Contract #: 04-0120F4Cty: SF/ALA Rte: 80 PM: 13.2/13.9File #: 69.25B**QUALITY ASSURANCE -- NON-CONFORMANCE REPORT****Location:** Changxing Island, Shanghai, China**Report No:** NCR-000903**Prime Contractor:** American Bridge/Fluor Enterprises, a JV**Date:** 23-Nov-2010**Submitting Contractor:** Zhenhua Port Machinery Company, Ltd (ZPMC), Changxing Island**NCR #:** ZPMC-0865**Type of problem:**

Reference Description: New Weld Procedure Not Followed (Rager/McQuaid)**Description of Non-Conformance:**

To:	AMERICAN BRIDGE/FLUOR, A JV 375 BURMA ROAD OAKLAND CA 95607	Date:	25-Nov-2010
Dear:	Mr. Charles Kanapicki	Contract No:	04-0120F4 04-SF-80-13.2 / 13.9
Attention:	Mr. Thomas Nilsson Project/Fabrication Manager	Job Name:	SAS Superstructure
Subject:	NCR No. ZPMC-0865	Document No:	05.03.06-000860
Reference Description:	New Weld Procedure Not Followed (Rager/McQuaid)

The weld is identified as DP-3101-001-23

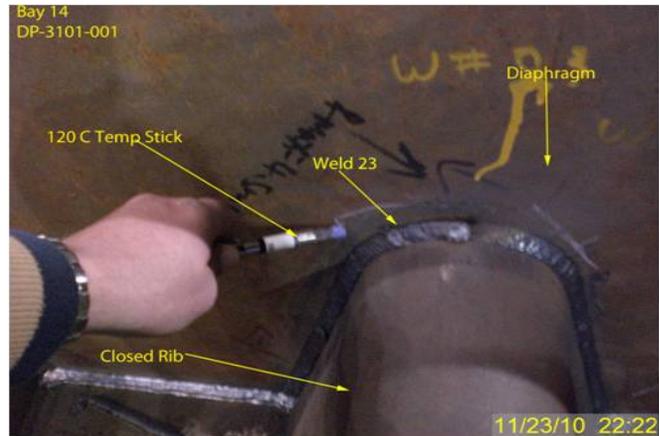
During Caltrans QA in process observations of the fabrication of DP-3101-001 this QA discovered the following issue(s): ZPMC welding personnel did not appear to be following the NEW WELD PROCEDURE (Rager / McQuaid) The following requirements were not followed:

5. Postweld Thermal Treatment (5A, 5B, 5D)

The welding process used was Flux Cored Arc Welding (FCAW)

The area was being preheated using electric strip heaters.

The weld is a Fillet joining Closed Rib to Deck Panel Diaphragm

CT acknowledges contractor's response. However, successful NDT will close this NCR.

Normal NCR closure package with NDT reports shall be submitted with the NPR to close out the NCR.

This proposed resolution is acceptable. The documentation received is sufficient and the Department concurs that Non-Conformance ZPMC-0865 is closed.
